Serial Nr.: 10/052,113
Art Unit: 2631

AMENDMENTS TO THE DRAWINGS:

REMARKS

FIG. 1

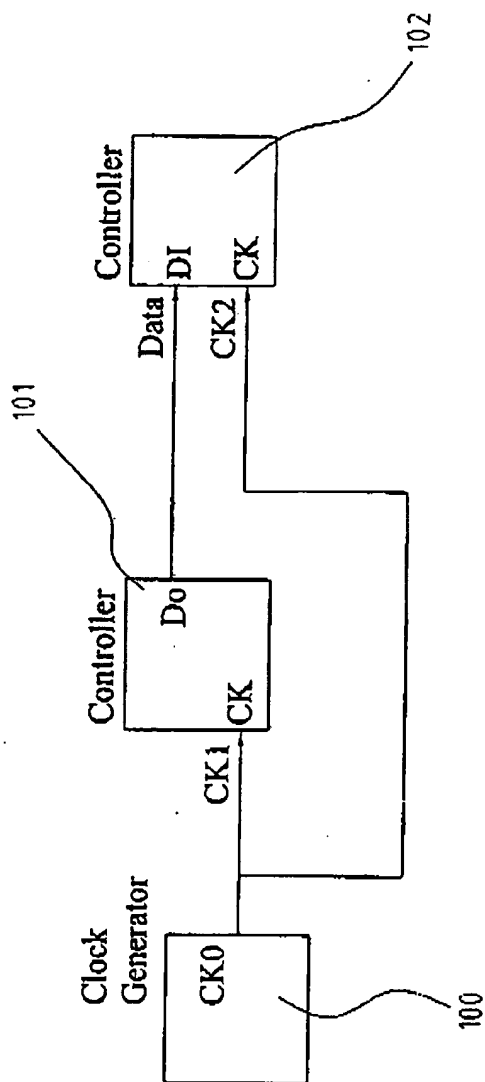
FIGs. 1 and 2 are amended to include a legend --Prior Art-- in each drawing. Annotated sheets showing marked-up changes for each drawing are submitted for approval.

The above amendment has been made without prejudice. Claims 1-2 and 4-11 are now in full condition for allowance. FIGs. 1 and 2 have been amended to include a legend --Prior Art-- as shown in the attached drawings submitted by FAX for approval. Replacement sheets of the drawings will be submitted by post office mail to ensure adequate quality for patent publication after the application is allowed. Applicants respectfully request that a timely Notice of Allowance be issued for this application.

(PRIOR ART)
